# Access Compliance Report

### (Curb Ramps)

Intersection ID: 52583	Main Street: NEW_RENAISSANCE_WY	Cross Street: BURNETTE_AV	Location: NE
ADA ID: 23F35B87C822	Ramp Type: Directional1	Initial Pass/Fail: Fail	Overall Compliance: No
Codes/Mitigation Info/Possible Solution		Field Measurements/Component Compliance	
Severity Score: 12.5

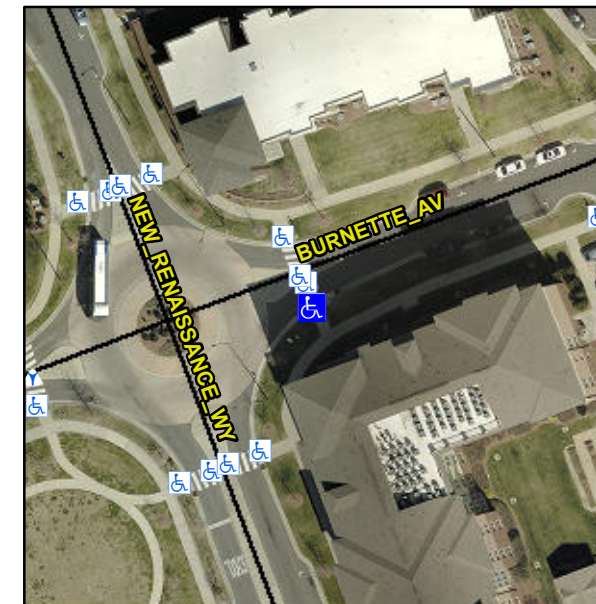
**R304.2.2**

**Remove & Replace Entire Ramp.**
